MFN 08-844

**Subject: Response to Portion of NRC Request for Additional Information
Letter No. 256 Related to ESBWR Design Certification Application
– Electrical Power - RAI Number 8.2-14 S01**

8.2-14 S01

DCD Tier 1, Figures 2.13.1-1 sh. 2 and 2.13.5-1, and Tier 2 Subsections 1.2.2.13.5, 8.1.1, 8.1.5.2.2.1, 8.3.1.1.2, 8.3.1.1.3, 14.2.8.1.67, 16B.3.8.4, 16B.3.8.5, 16B.3.8.6, Figures 8.1-4, 8.3-1, 8.3-3 and Table 8.3-4 will be revised in Revision 6 as noted in the attached markup.

Figure 2.13.1-1 Sh 2.
Onsite AC Power System Functional Arrangement

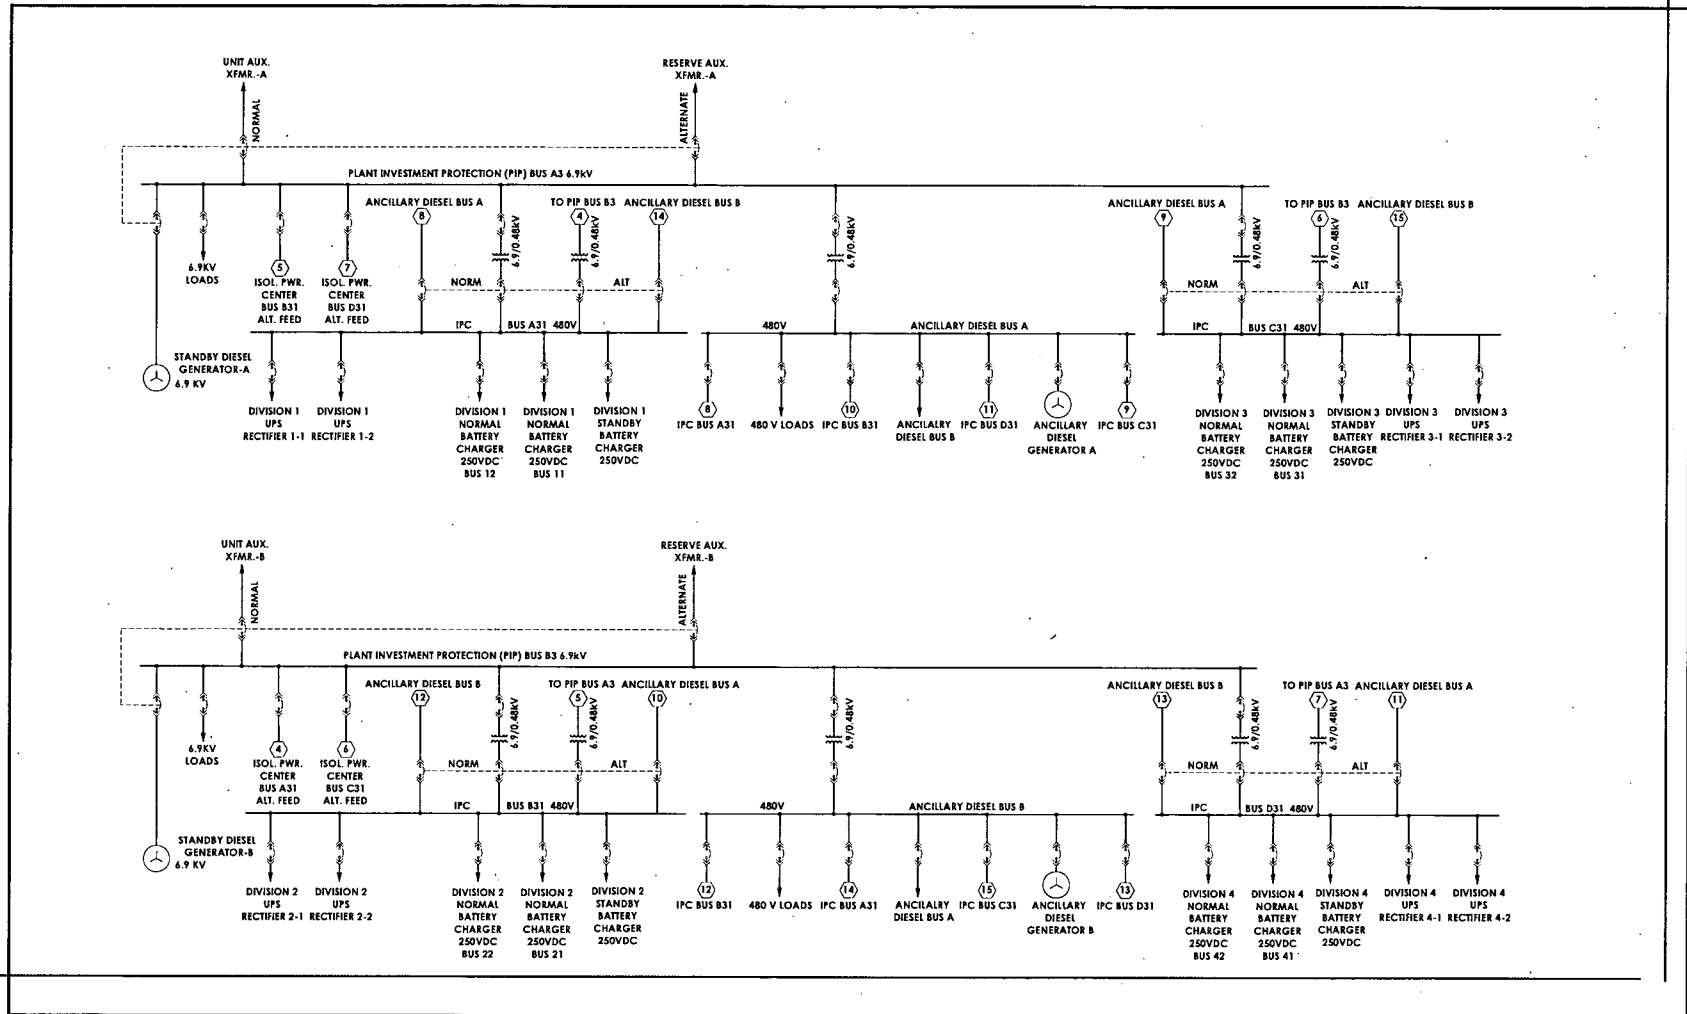
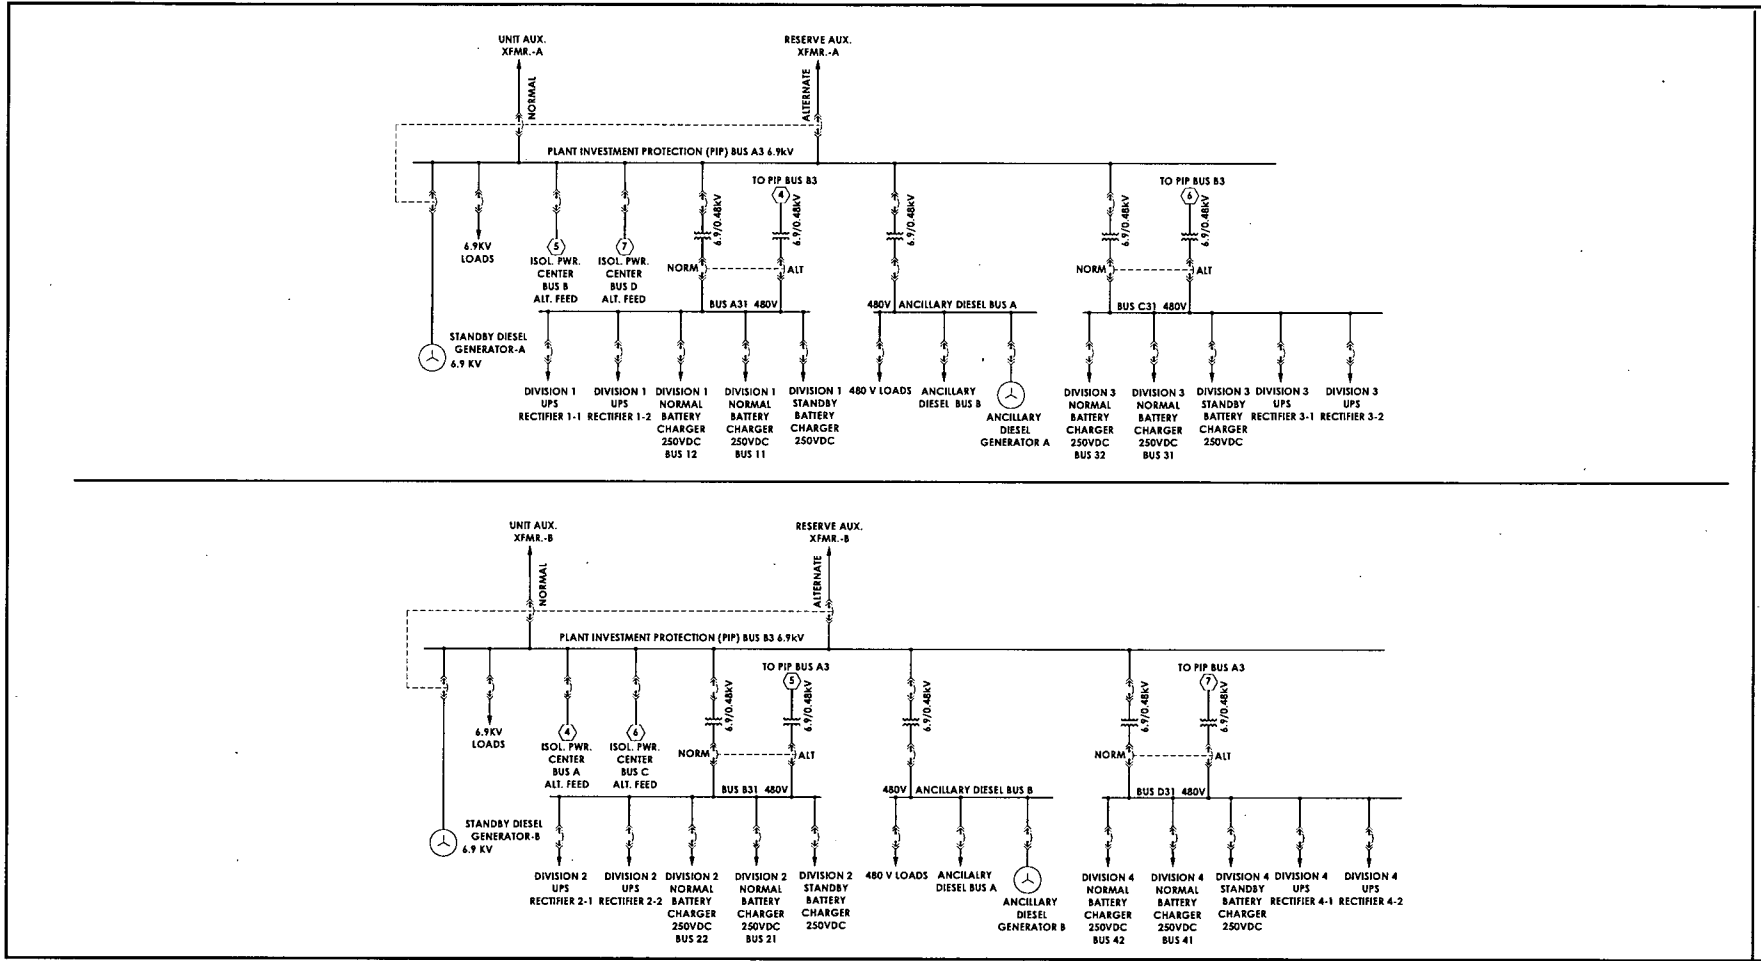
(3) Due to the potential for disruptive voltages and frequencies reaching the safety related loads, the safety-related UPS bypass transformers are eliminated from the ESBWR design. The 100% redundant UPS rectifiers and inverters within each division negate the need for a bypass transformer as was used in previous designs using only a single UPS rectifier and inverter. The battery chargers and UPS will be designed to have the required fault clearing and load inrush current capability without the need to switch to a bypass source. Each inverter within a division can be taken out of service for maintenance without the need to de-energize the UPS bus, however the division will be inoperable per the Technical Specifications due to the reduced battery capacity in this configuration. DCD Tier 1 and Tier 2 will be revised to reflect removal of the safety-related UPS bypass transformer.

Figure 8.3-1. Safety-Related 480 Volt Power Centers

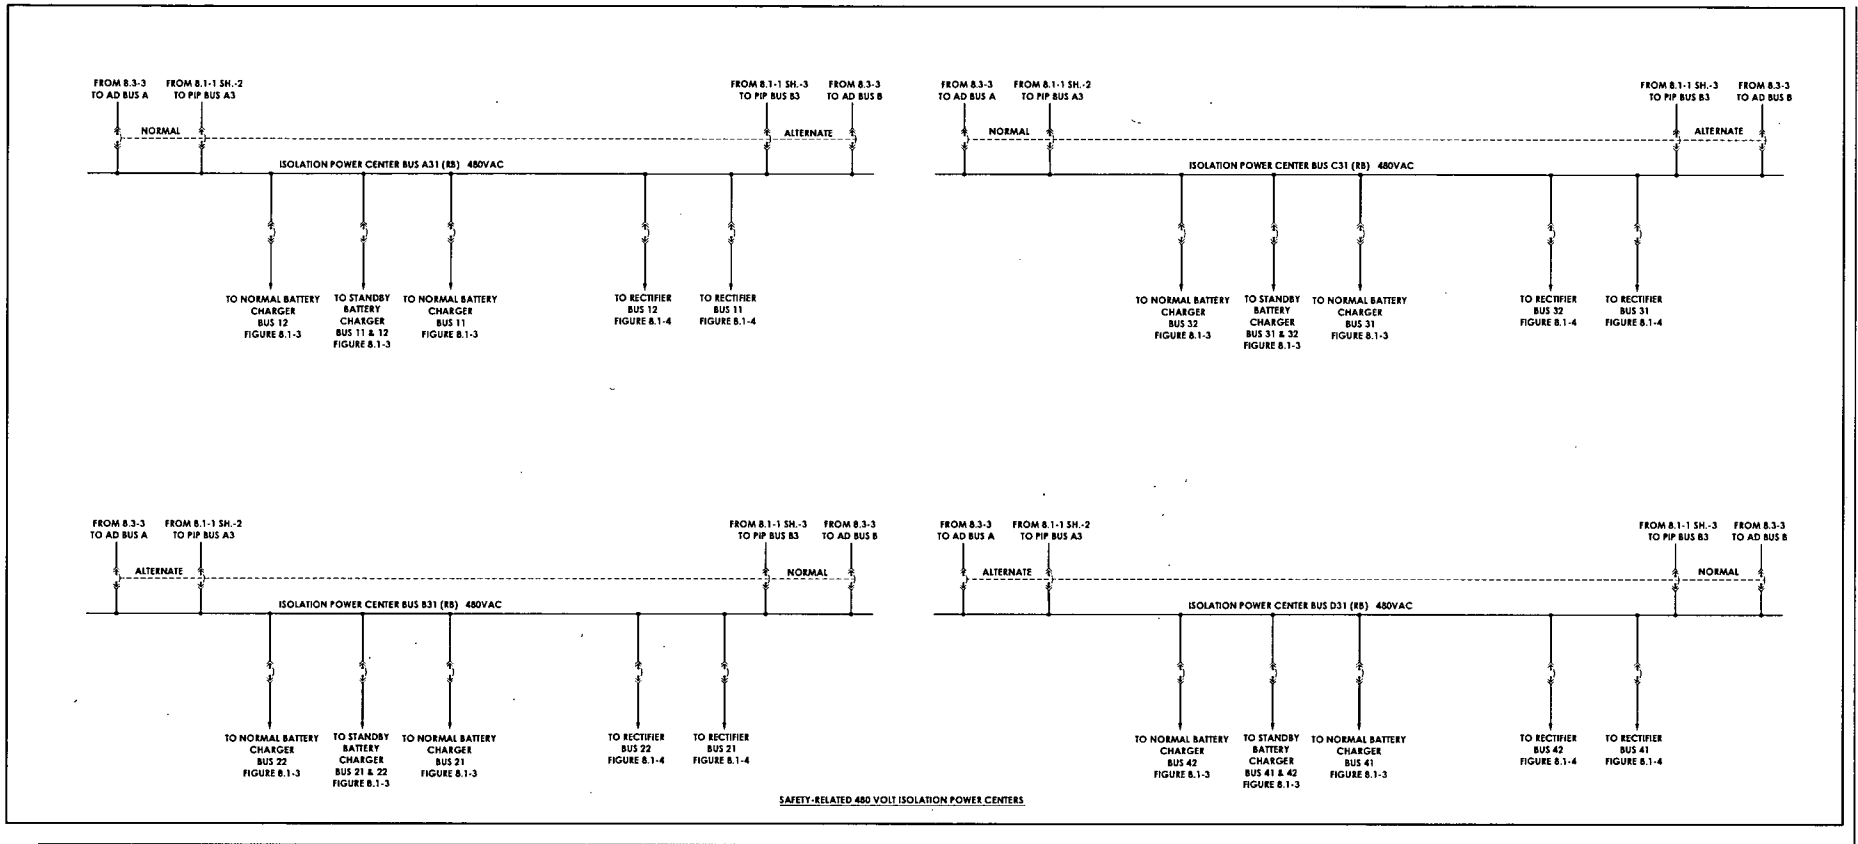
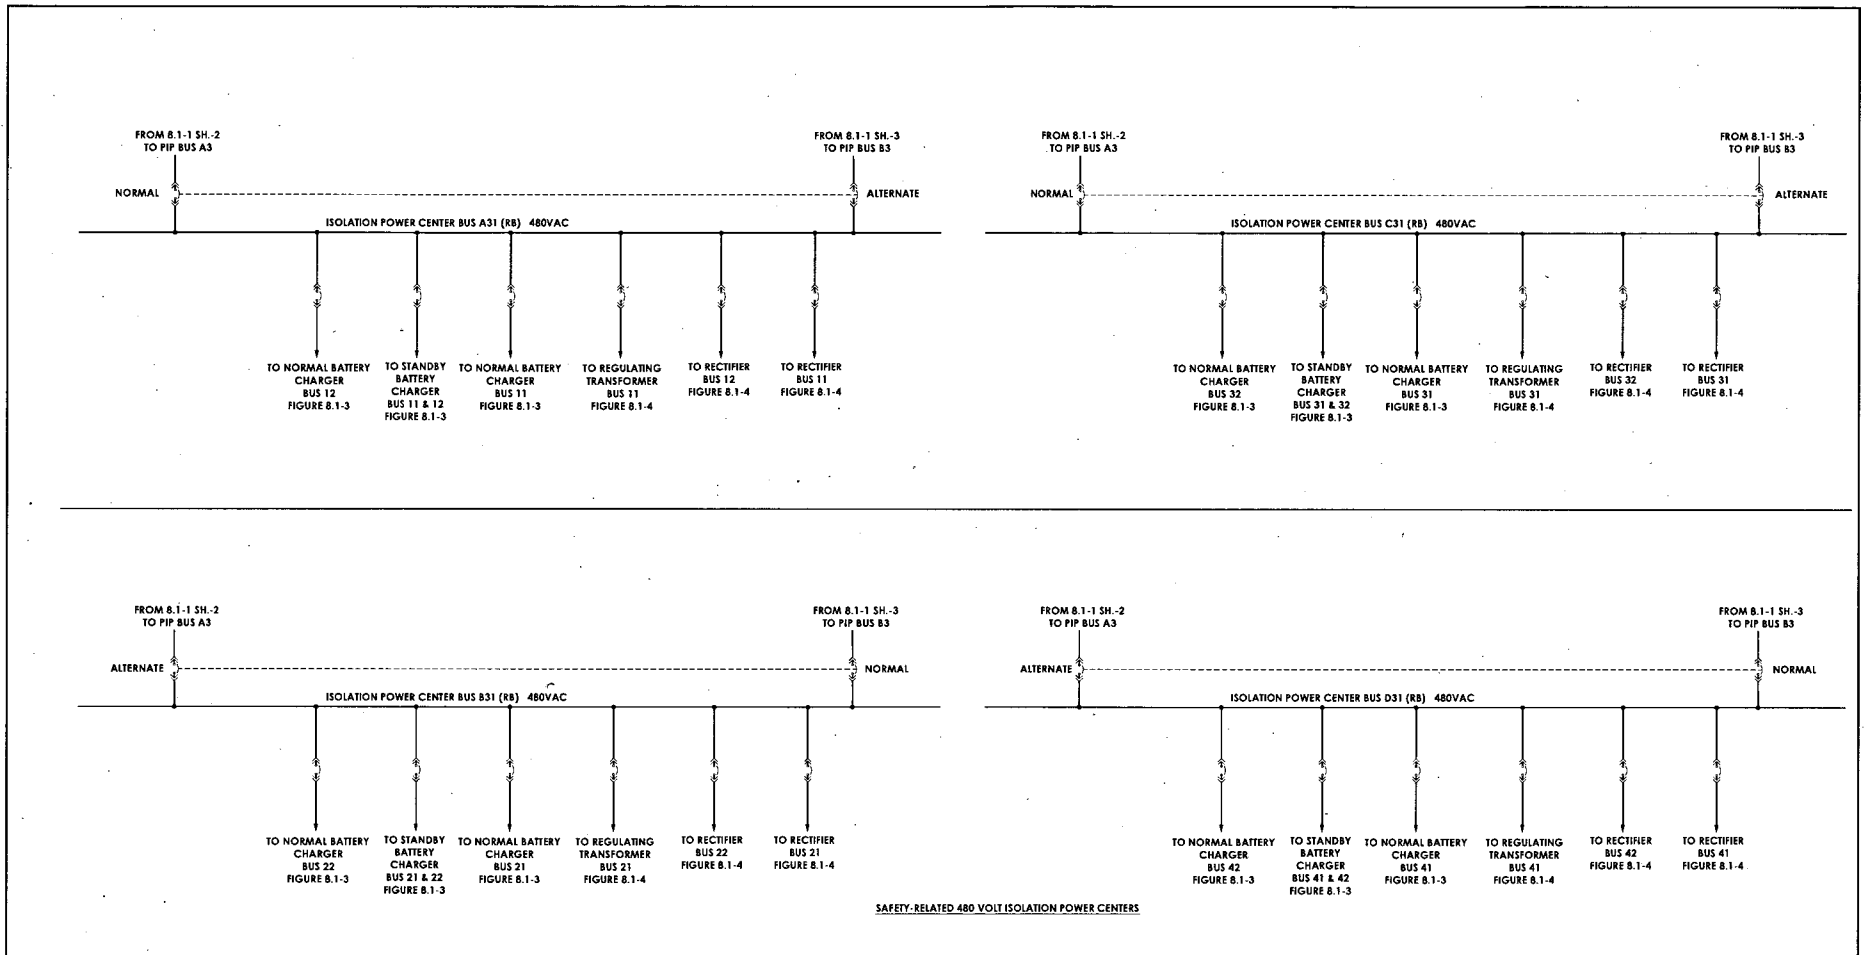
These loads consist of the safety-related battery chargers, and rectifiers, and ~~regulating transformers~~ as discussed in Subsections 8.3.2 and 8.3.1.1.3. In addition, there is no safety-related lighting that operates directly from the 480 VAC in the ESBWR design. The lighting system is discussed in Chapter 9.

Figure 8.3-3. Ancillary Power Functional Figure

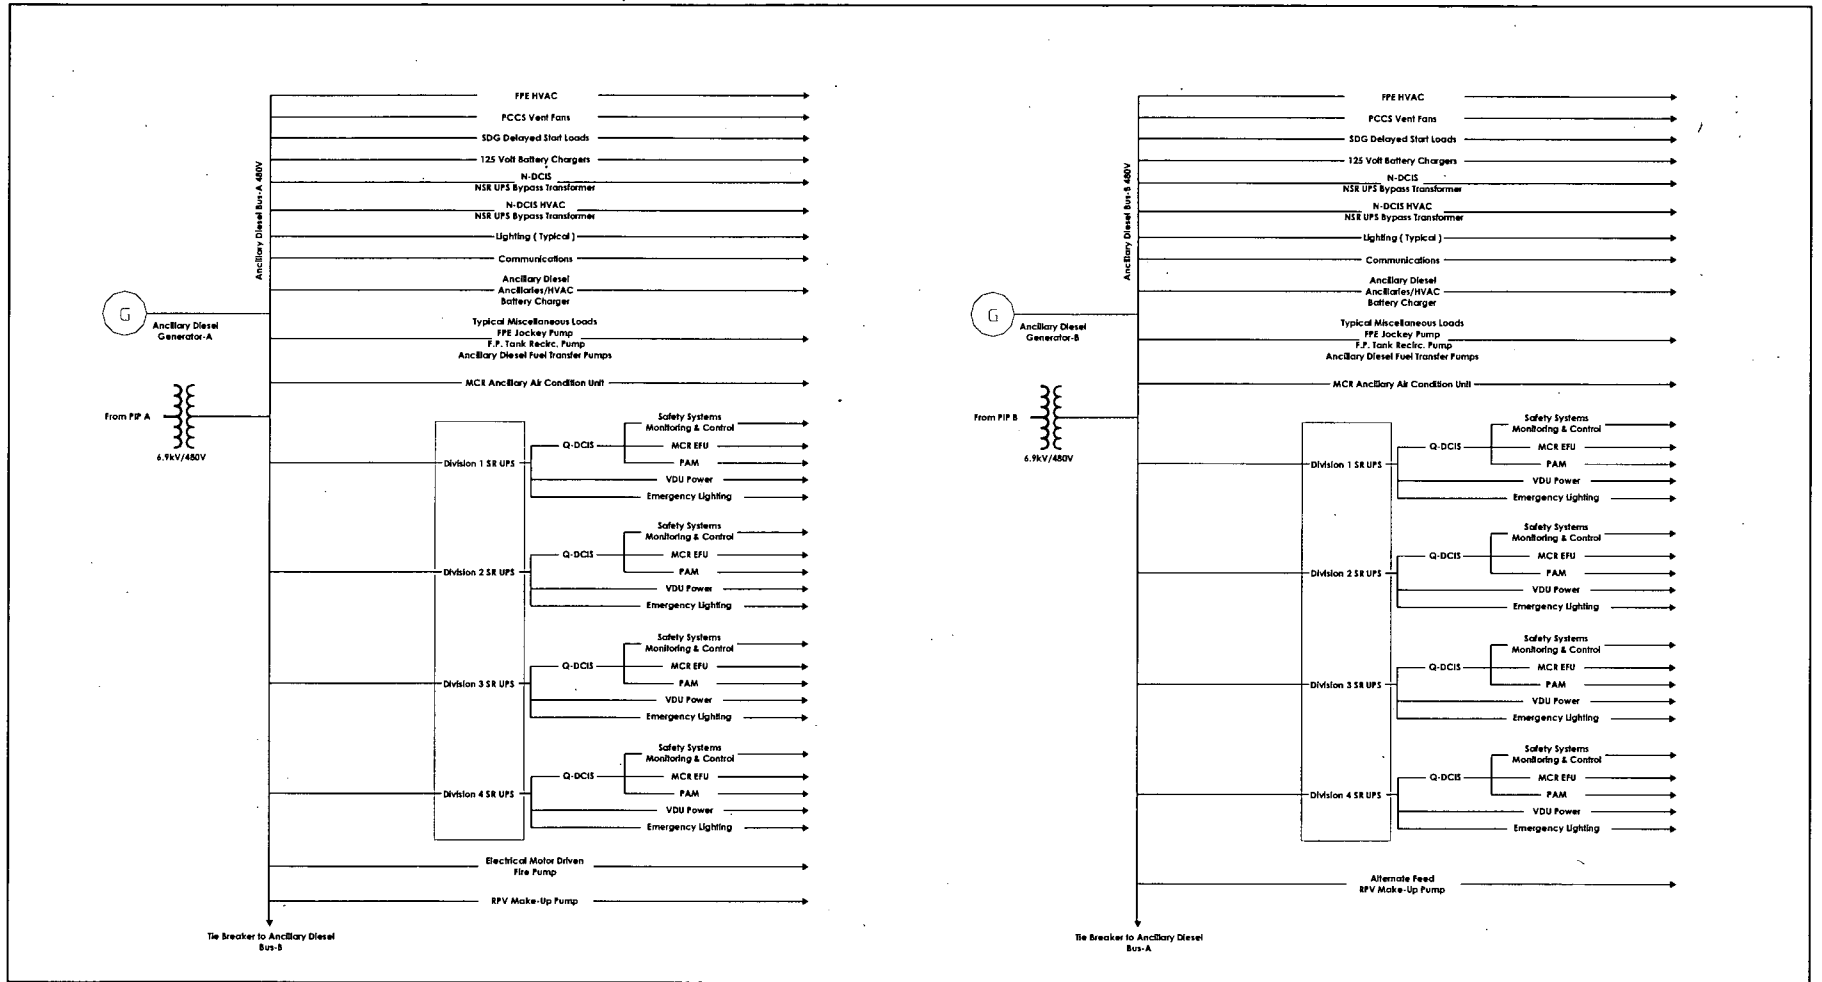
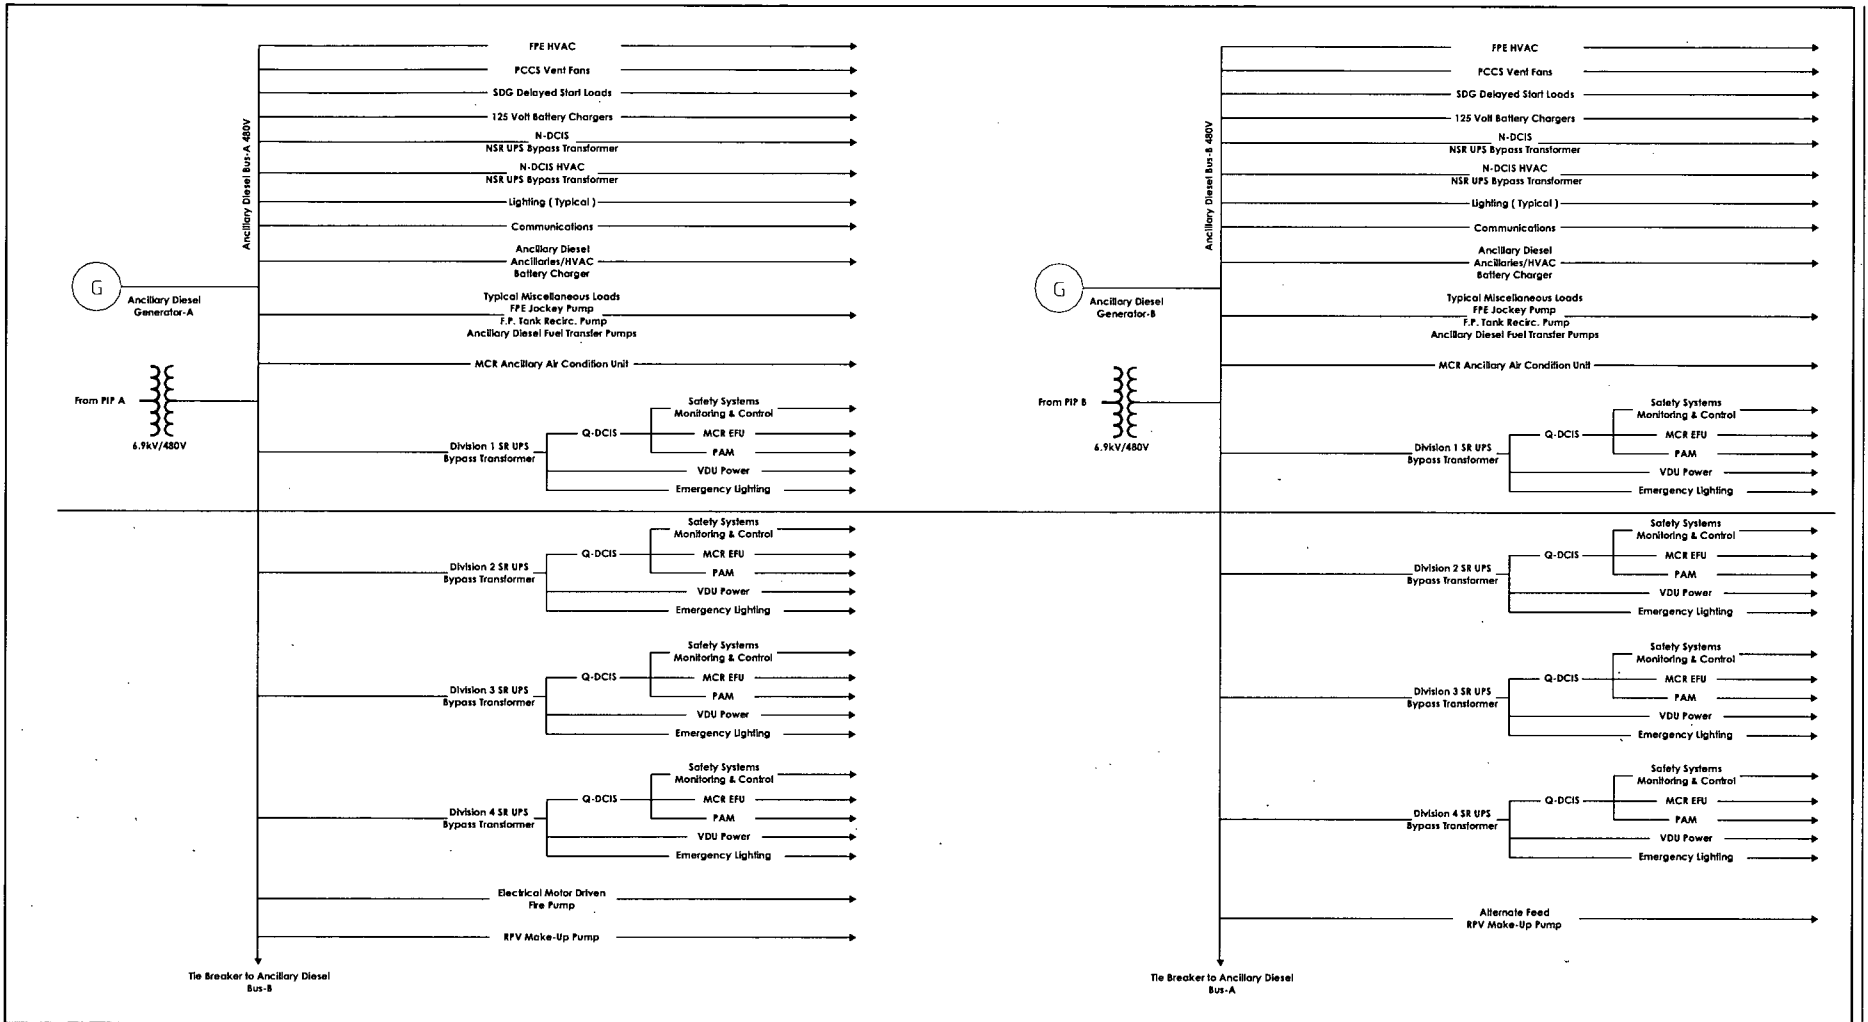
- Proper operation of auxiliary systems such as those used for starting, cooling, heating, ventilating, lubricating, and fueling the ADGs; and
- Capability of the system to allow use of the ADGs to supply power to the safety-related 120-volt Uninterruptible buses through ~~480/120 regulating step down transformer~~ the Isolation Power Center buses.
